RAI Volume 3, Chapter 2.2.1.4.2, First Set, Number 2, Supplemental Question:

Figure 1. Cumulative Distribution Function of ^{129}I Median Travel Time through the Human Intrusion Borehole (300 epistemic samples)

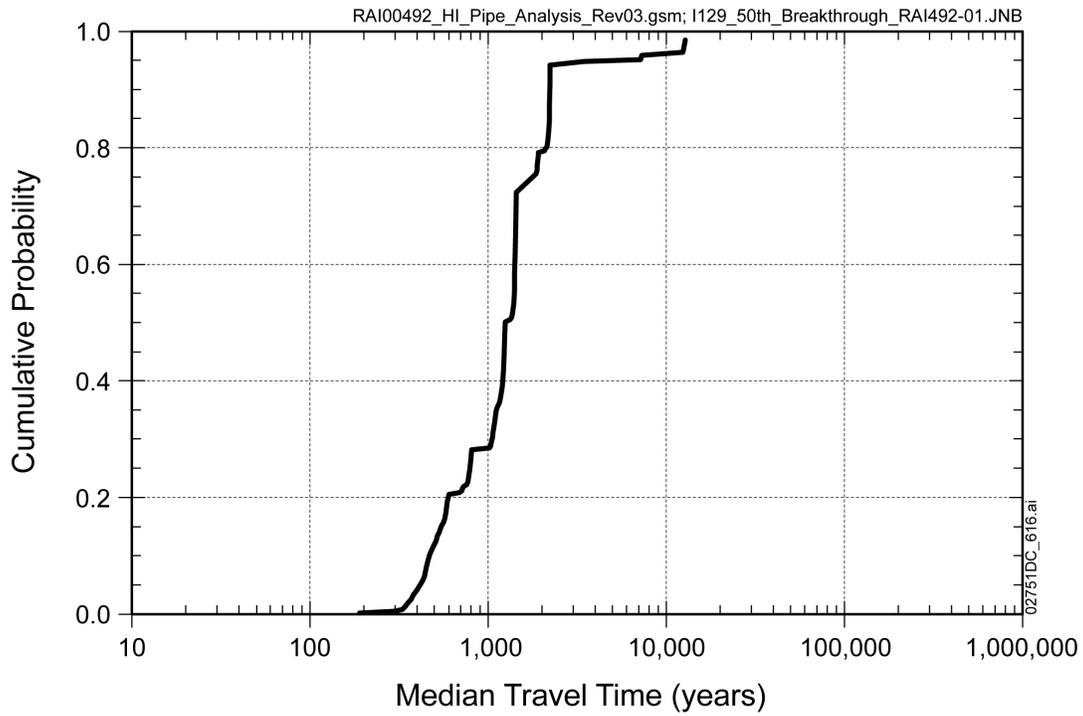
The DOE response indicates that, despite the very short travel time in the borehole, the relatively slow matrix diffusion process has a significant impact (e.g., non-sorbing species increase in travel time to 1,250 yrs. and a moderately sorbing species increase to 64,000 yrs.). Although the DOE has provided information to support the increases in travel time, travel times of this length appear to be inconsistent with the travel times estimated for fractures in the UZ (e.g., the SAR figures 2.3.8-50 and 51). If the borehole travel times are estimated based on the host rock properties (fracture and matrix), clarify the basis for such different travel times associated with transport in the fractures of the host rock vs. the assumed fractures in the borehole.

For comparison with the above predicted travel times through the unsaturated zone component of the Lower Natural Barrier, a modified version of the verification case for the human intrusion borehole transport model described in Section 7.2.4.1.12[a] of *Total System Performance Assessment Model/Analysis for the License Application* (SNL 2008a) was analyzed over the epistemic sample size of 300 realizations. The simulation assumed a release of one kilogram of ^{129}I and ^{237}Np in the first year to the human intrusion borehole. The median transport times for ^{129}I (non-sorbing species) through the unsaturated zone human intrusion borehole from the 300 realization verification case are predicted to be in the range of 416 to 5,320 years (Figure 1) based on the 0.05 and 0.95 probabilities. Note that the median travel times represent the cumulative breakthrough curve times associated with the cumulative release of 50% of the source mass. The median value of the median travel times is approximately 1,240 years. The distribution of breakthrough curves is dependent on the sampled values of the matrix diffusion
